RENESAS TECHNICAL UPDATE

Product Category	MPU/MCU		Document No.	TN-RH8-B0567B/E	Rev.	2.00
Title	RH850 G3M stuck Issue		Information Category	Technical Notification		
Applicable Product	RH850/C1H, C1M RH850/D1M1A, D1M1H, D1M2 RH850/E1L, E1M-S RH850/F1H RH850/P1H-C, P1M-C	Lot No.	Reference Document	See related documents below.		
		All

We confirmed that the G3M CPU gets stuck while running a certain program code.

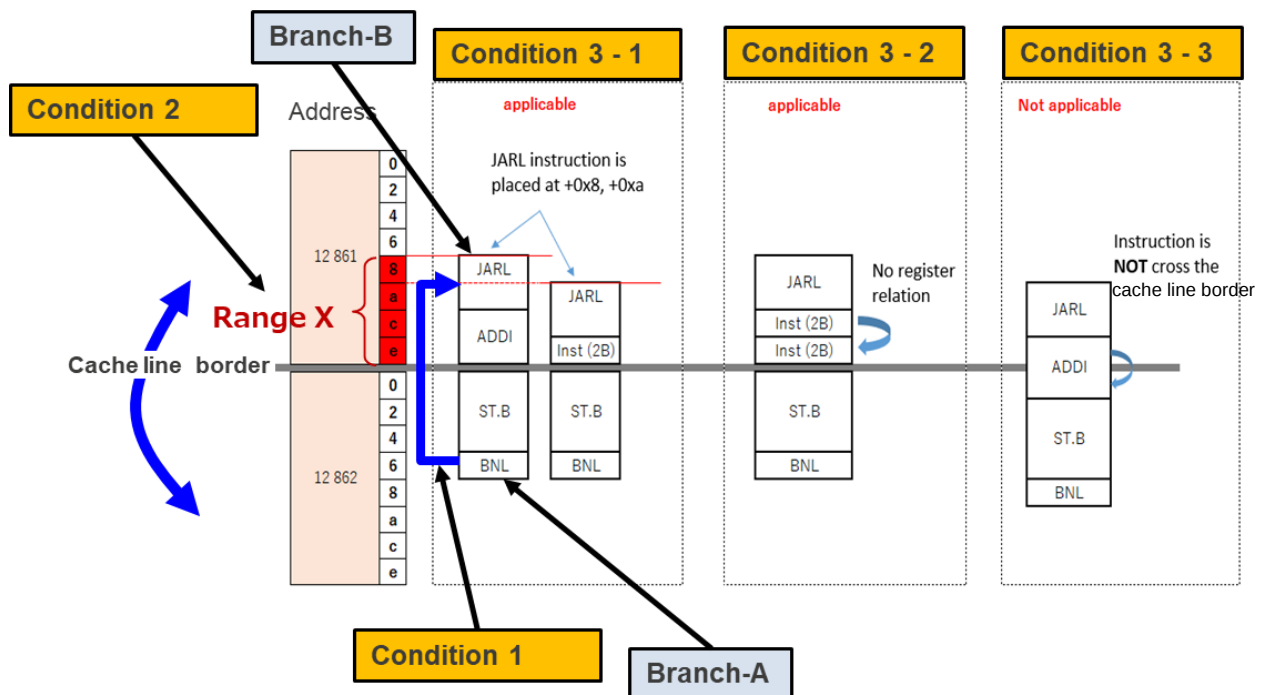
Condition 2: [Branch instruction B] place to after jump target of [Branch instruction A]. And, each instruction address are place to different cache line (16-byte placement block) and adjacent.

3-1. [Branch Instruction B] is placed to address +0x8 ~ +0xf [Range X]

3-2. 1 or 2 instruction are placed between [Branch instruction B] and cache line border except following condition

- [1 instruction]: SYNCI
- [2 instruction]: 2 instruction doesn't use same register (doesn't occur conflict of register)
or either instruction is NOP/SYNCI/SYNCP/SYNCM/part of FPU instruction

➤ Branch Prediction Entry Status

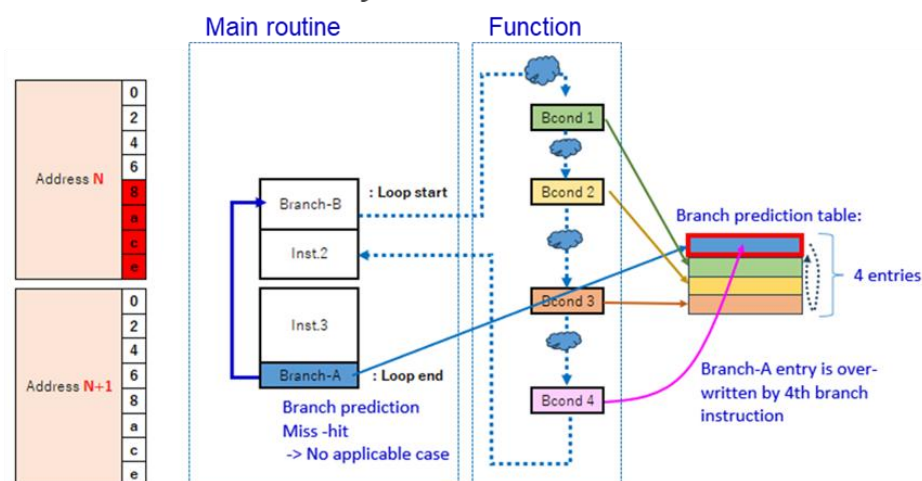
One of the dynamic conditions is the number of branches in the code sequence from [Branch instruction B] (the call to "Function")

- From the viewpoint of the HW mechanism, one of the applicable conditions is that "the branch prediction when [Branch instruction A] is executed is a hit".
- If the "function" called from [Branch instruction B] has four or more branch instructions (Bcond 1,2,3,4) <*1> the branch prediction table entry for [Branch instruction A] will be lost by re-executing the [Branch instruction A], and it will not be applicable.

Register No. (regID, selID)	Symbol	Function	Access Permission
SR8.12	BPCR	Branch prediction control	SV

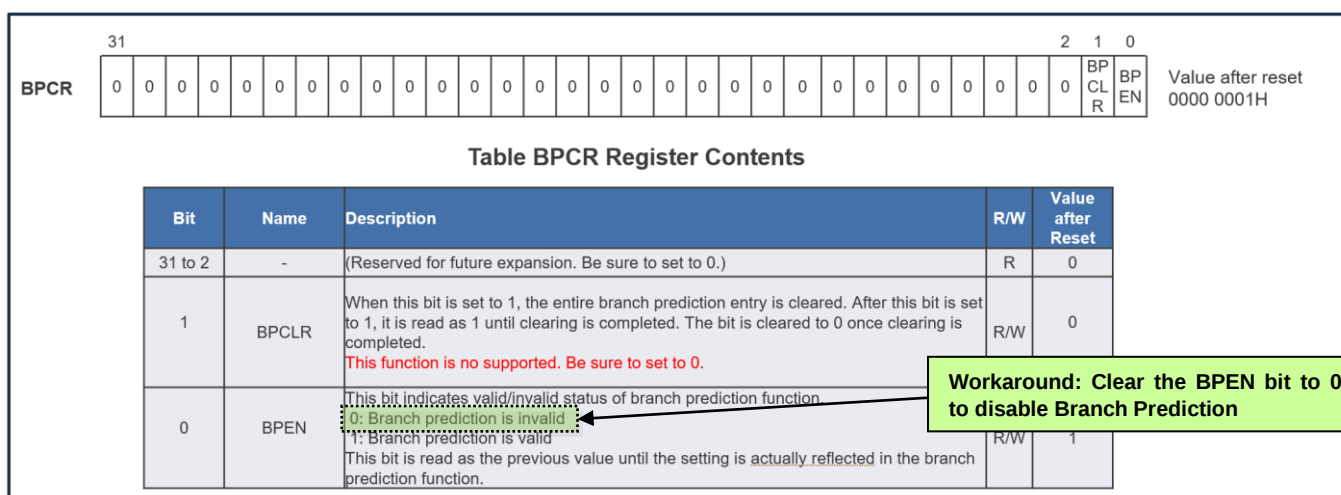
The G3M "Branch Prediction" feature is enabled after a reset (default) and can be disabled with bit 0 of the Branch Prediction Control Register (BPCR). It is not available in the current users manual.

How to disable the “branch prediction function”

(2) How to disable the branch prediction capability

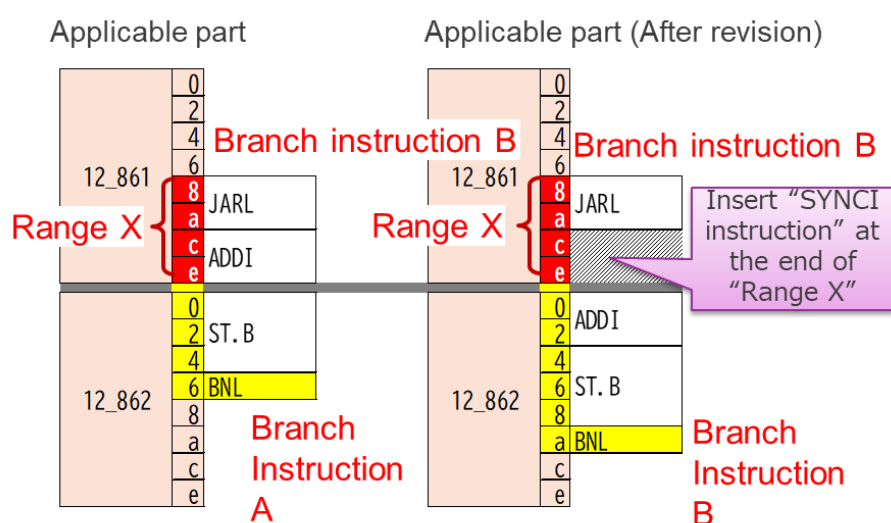
- (1) Disable the “branch prediction function” of the CPU core.
- (2) Prevent branch prediction hit against [Branch instruction A].

Insert SYNCI instruction at the end of “Range X” in all relevant parts.
